# HISTORIC PRESERVATION COMMISSION REPORT

**Case Name:** Roman Townhouse Driveway Pavers

**Case Number:** 47-HP-2020

**Request:** Approval of a Certificate of Appropriateness-Historic Resources for the replacement of the concrete driveway with concrete pavers, at a townhouse located in the Villa Monterey Historic District Units 1-7 Historic District.

71 SITE PLAN  
1/8" = 1'-0"

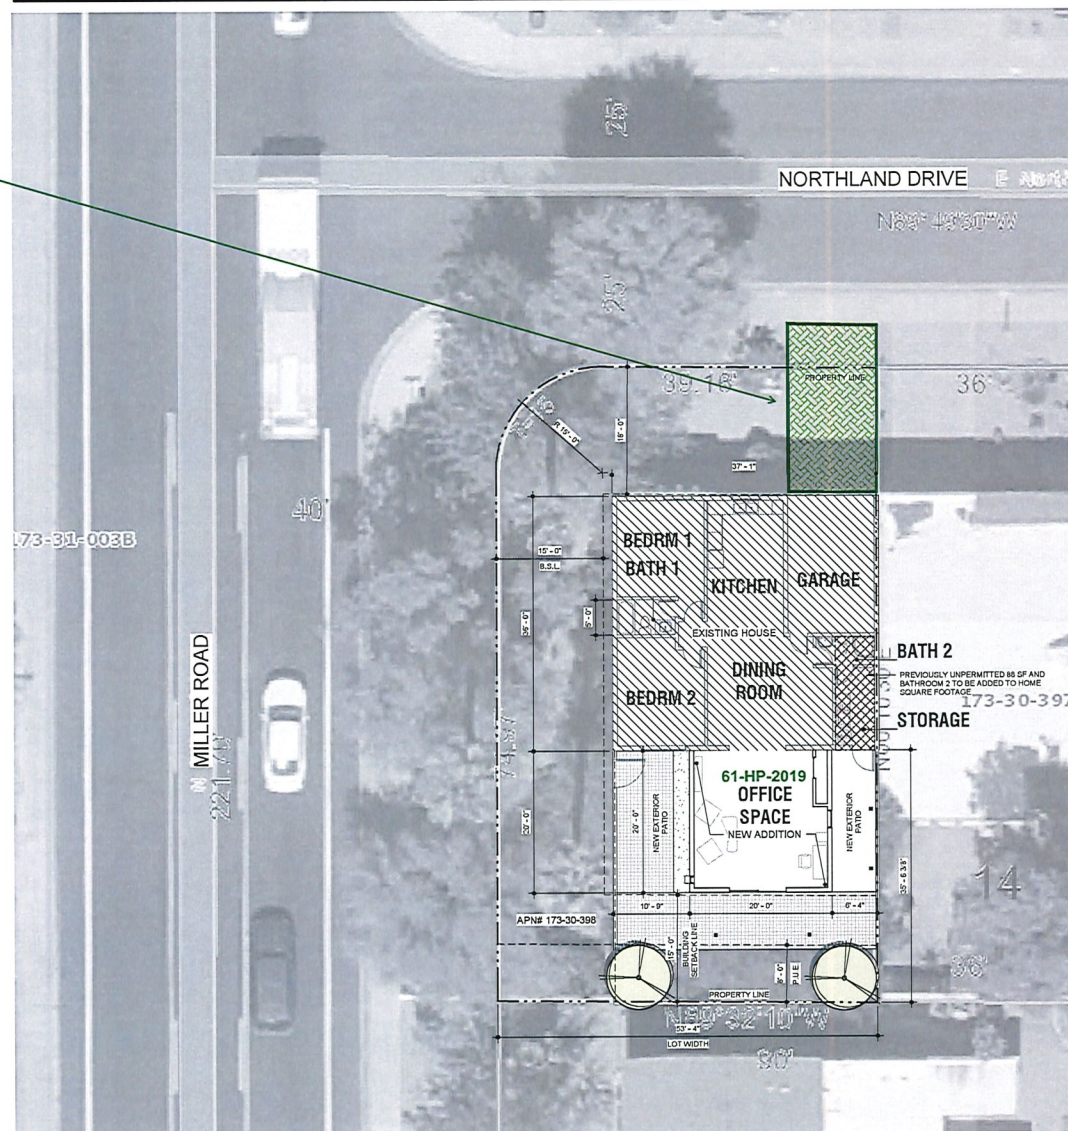
*Staff Analysis:* The applicant does not propose increasing the improved driveway area.

*Staff Analysis:* The applicant does not propose the addition of a parking bay. The applicant is proposing providing concrete pavers to replace the existing concrete slab driveway. The applicant proposes using variable color tone and value, gray pavers in a stacked linear pattern for the driveway improvements.

1. Except as required by the Scottsdale Revised Code (SRC), the Design Standards and Policies Manual (DSPM), and the other stipulations herein, the site design and construction shall substantially conform to the following documents:
  - a. The location and configuration of all site improvements shall be consistent with the site plan with a city staff date of February 6, 2019
  - b. Paver materials shall be consistent with paver images with a city staff date of May 18, 2020. Colors limited to the light gray concrete color. Paver pattern limited to a stacked linear pattern – not an angled or cross pattern.

1. DRIVEWAY. Driveway improvements shall meet the following design guidelines:
  - a. The maximum linear grade of a driveway shall be 18 percent and the average grade for the length of the driveway shall be 12 percent,
  - b. Paved driveway concrete pavers must demonstrate that there would be no erosion from the surface and the construction will allow for the loading of emergency vehicles.
